**PLANNING REPORT IN ACCORDANCE WITH
SECTION 179 3(a) OF THE PLANNING AND DEVELOPMENT
ACT 2000 (as amended)**

Re: Construction of a traffic management scheme comprising the following development works (as revised):
Modified traffic lane widths along the N21 within Abbeyfeale town centre with revised parking layout;
New traffic signals junction controls and associated layouts will be installed at the Main Street/ Church Street and Main Street/ Colbert Terrace junctions with controlled pedestrian crossings on all arms of the proposed traffic signal junctions;
Upgrade of mini roundabout junction at Colbert Terrace/ Tesco access;
Provision of road widening at junction of Colbert Terrace and New Street, which involves demolition of one property;
New coach parking set downs on Main Street;
Provision of coach parking to rear of Main Street and modifications to Grove Crescent public car park;
Development of an uncovered pedestrian link between Main Street and Grove Crescent public car park requiring the modification of an existing building on Main Street;

Planning Reference No: 17/8019

Figure 4: Proposed traffic management plan – as modified

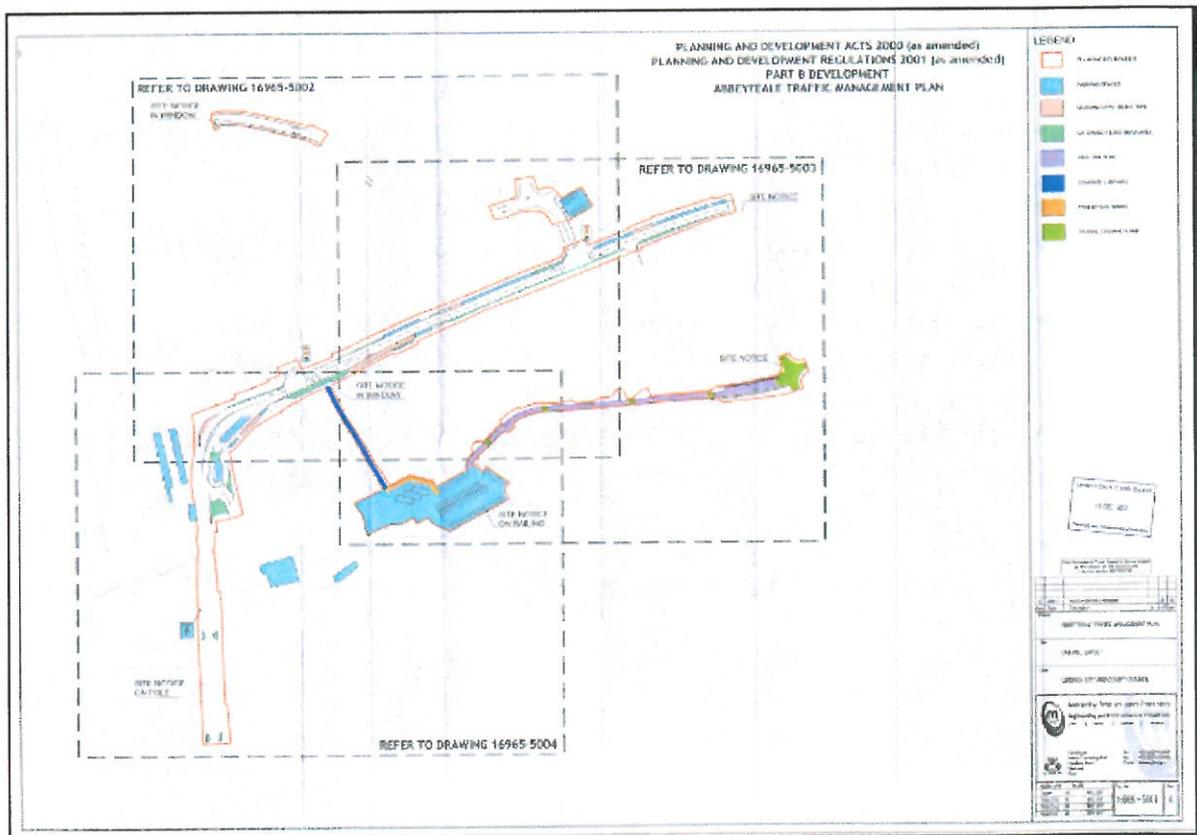
The Abbeyfeale Traffic Management Plan has been modified as per drawing number 16965-5013 Rev C as follows: -

- Modified traffic lane widths along the N21 within Abbeyfeale town centre with revised parking layout.
- New traffic signals junction controls and associated layouts will be installed at the Main Street /Church Street and Main Street /Colbert Terrace junctions with controlled pedestrian crossings on all arms of the proposed traffic signal junctions.
- Upgrade of mini roundabout junction at Colbert Terrace/Tesco access.
- Provision of road widening at junction of Colbert Terrace and New Street, which involves demolition of one property.

The modified traffic management plan includes Car Parking accessed directly off the Main Street (at Riordan's pub which will be demolished), this parking will be visible from Main Street and links to the existing Car Park at Grove Crescent. It is anticipated that due its close proximity to Main Street this minimises the impact of parking which has been removed. Four coach/ bus parking bays are provided at the following locations: - Main Street – one bus bay on the south side of Main Street near Athea junction; Main Street – an enhanced bus bay at Father Casey monument and two bus bays at Grove Crescent Car Park. It is not considered feasible to relocate the Fire Station to provide parking. The scheme includes for road widening at the junction of Colbert Terrace and New Street and the provision of footpaths on both sides of Colbert Terrace.

The revised traffic management plan provides for the reconfiguration of Car Parking, loading bays and bus/coach bays between Cedarville and The Square, along Main Street. Following the public information day and submissions on the planning file, additional parking has been provided where feasible on Main Street and The Square. There is a reduction of nineteen equivalent Car Parking spaces on Main Street. However, forty-two additional Car Parking spaces are being provided in the revised scheme: - seven number in The Square; eleven number at the rear of McMahon's Butchers and twenty-four at O'Riordan's Pub. These additional parking spaces are considered to be centrally located and result in an overall net gain of twenty-three Car Parking spaces.
